REMARKS

Application No. 10/823,713
Amendment dated August 4, 2005
Reply to Office Action of May 5, 2005
Annotated Sheet Showing Changes

FIG. 7A

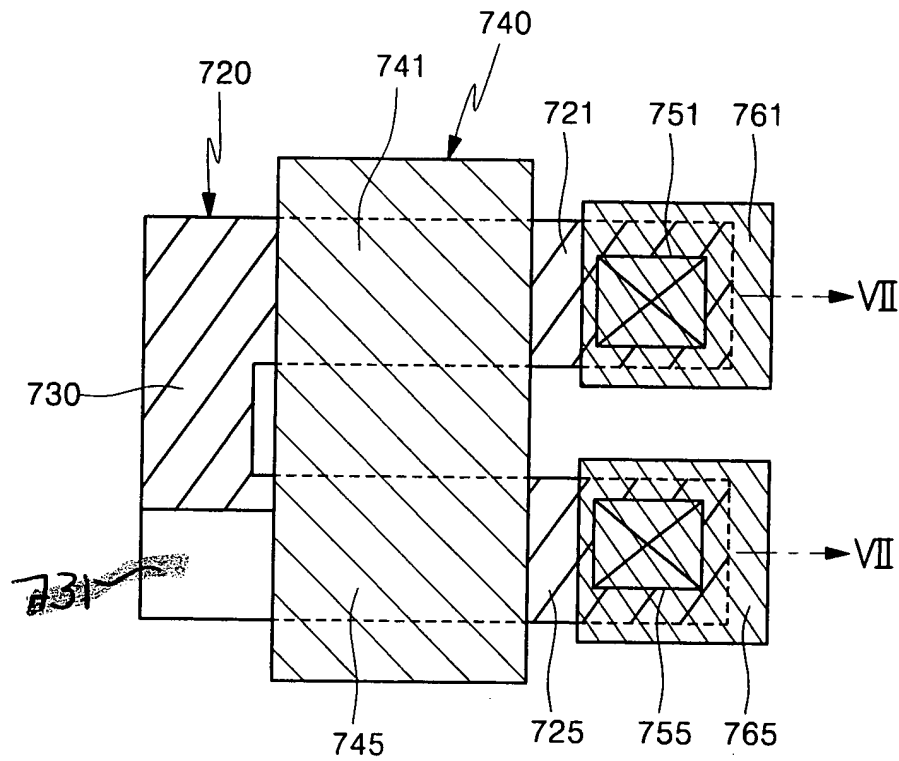
On page 2, numbered paragraph 2 of the Office action, the Examiner objected to Fig. 7A of the drawings because the "bottom left corner of Fig. 7A has not been labeled and it is not clear whether it is part of the drawing." To resolve this objection, Applicants have amended the drawing and provided a replacement drawing sheet in compliance with 37 CFR 1.121(d).

On page 3, numbered paragraph 2 of the Office action, the Examiner objected to Fig. 6 and Fig. 7 because they do not include reference numerals 661, 665, and 321, which are mentioned in the description.

Applicants amended Fig. 7A to include reference numeral 731 referring to the bottom left corner of Fig. 7A, which is a void area in the zigzag shape of the offset 730.

Applicants amended Fig. 7B to include reference numeral 731 at two locations related to the offset 730, which are void areas in the zigzag shape of the offset 730.

Applicants amended Fig. 7B to correct a clerical mistake to change reference numeral 321 to reference numeral 721, which is mentioned in the description.
